Statement of Response to An Bord Pleanála Pre-Application Consultation Opinion

**Proposed Strategic Housing Development
Lands at Auburn House (Protected Structure),
Little Auburn and Streamstown off the
R107 Malahide Road/Dublin Road
and Carey's Lane,
Malahide, Co. Dublin**

Applicant: Kinwest Ltd.

Fig. 12 – View of Auburn House from front lawn, looking west (Source: CCK Architects & Urban Designers Site Layout, Public Open Space drawing)

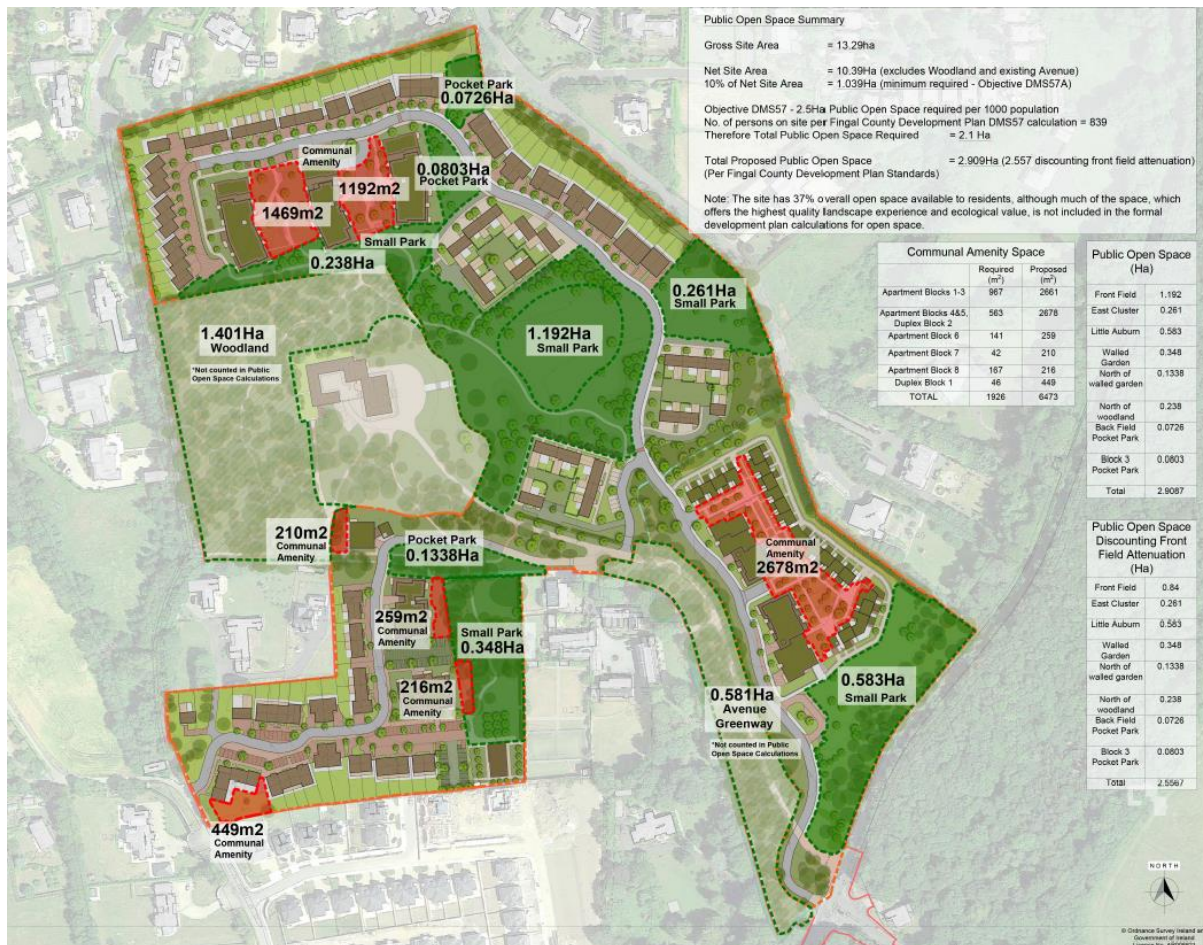
“Further consideration and elaboration of the documents as they relate to the design and layout of open space across the site, clearly identifying and defining public private and communal spaces”.

In further elaborating upon the design and layout of the open spaces across the site, TBS Landscape Architects have prepared a detailed landscaping plan and design report, along with sections and planting/material schedules, while CCK Architects & Urban Designers have set out on DWG No. 1902 P032 the breakdown of public and communal open space areas across the site. The Board are invited to refer to these for further details.

The proposed development exceeds the minimum quantum of open space areas including: 6,473 sq.m. of communal open space and 2.56 hectares of usable public open space (excluding attenuation areas and woodlands).

The collaboration between The Tree File and TBS Landscape Architects has informed in detail how the site is best developed with a view to managing and improving the woodland over time. A long-term woodland management plan is part of the proposals. A lot of the senior planting is coming to its end of life, and the plan will ensure continuity and renewal in a sustainable way. This will gradually restore the balance and control the advance of opportunist invasive species. This will add to the overall landscape character of the area and development.

While the hierarchy of open space as defined by the development plan results from this understanding, it should be noted that this site has so much to offer that is not technically included in development plan calculations. The greenway avenue and the woodland paths in particular will be an outstanding asset.
